MIL "ON" DTC P1CB7A2

Service Category Vehicle Interior

Introduction

Some 2016 model year Prius vehicles may exhibit a MIL "ON" condition with Diagnostic Trouble Code (DTC) P1CB7A2 (Motor Generator System Voltage Low). The Hybrid Vehicle Control Computer (ECU) logic has been modified. Follow the Repair Procedure in this bulletin to address this condition.

Figure 1. Location of Authorized Modifications Label for 2016 Prius

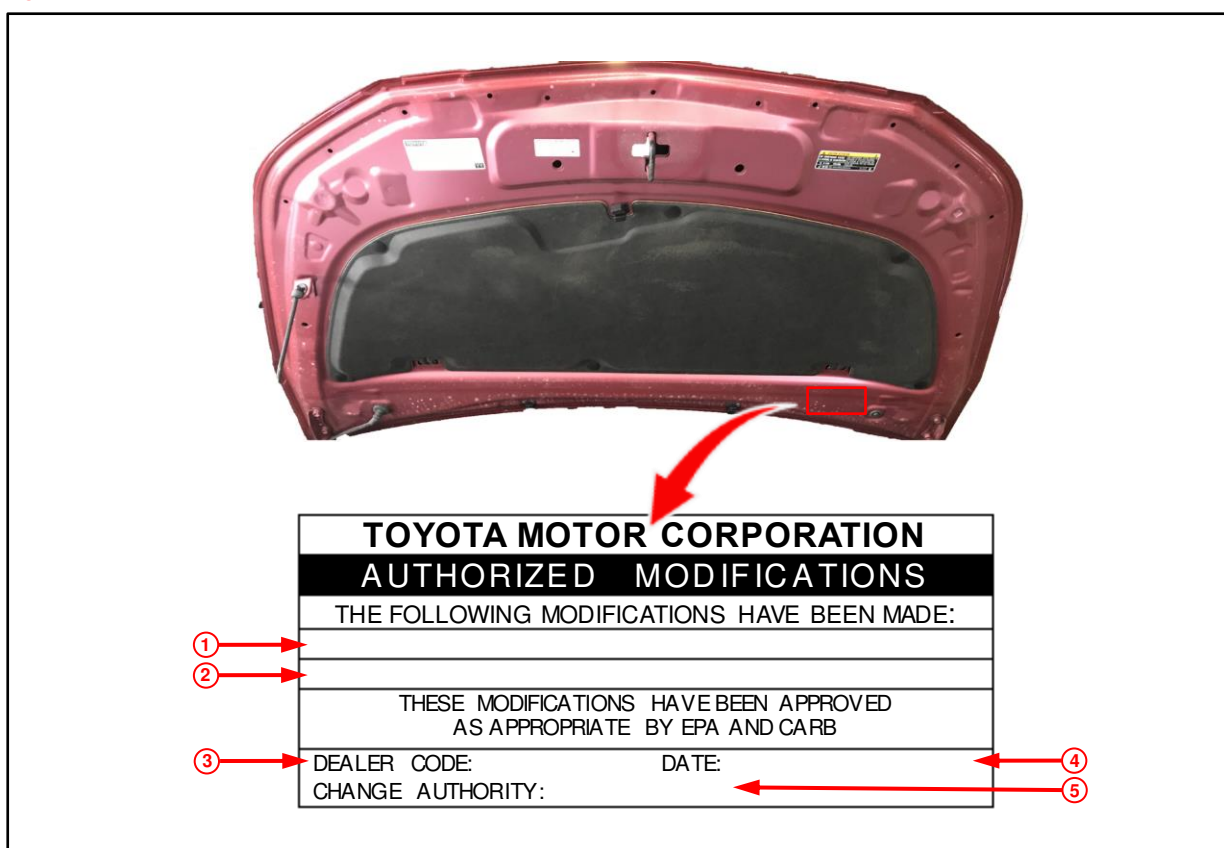
6. Check for the Authorized Modifications Label affixed to the vehicle in the location shown below. Confirm if the HV ECU calibration has been updated.

8. Prepare and install the Authorized Modifications Label.
 - A. Using a permanent marker, enter the following information on the label:
 - HV ECU part number [Refer to the **Parts Information** section for the **NEW PART NUMBER**]
 - Calibration ID(s) [Refer to the **Calibration Information** section for the **NEW CALIBRATION ID**]
 - Dealer Code
 - Repair Date
 - Change Authority [**This bulletin number**]
 - B. Affix the Authorized Modifications Label to the vehicle at the location shown in Figure 1.
The Authorized Modifications Label is available through the MDC, P/N 00451-00001-LBL.
9. Replace the inverter battery if required.
Refer to TIS, applicable model and model year Repair Manual:
 - 2016 Prius:
Engine/Hybrid System – Hybrid/Battery Control – "Hybrid / Battery Control: Inverter Battery: Removal / Installation"
10. Test drive the vehicle to confirm that the DTC does NOT reset.
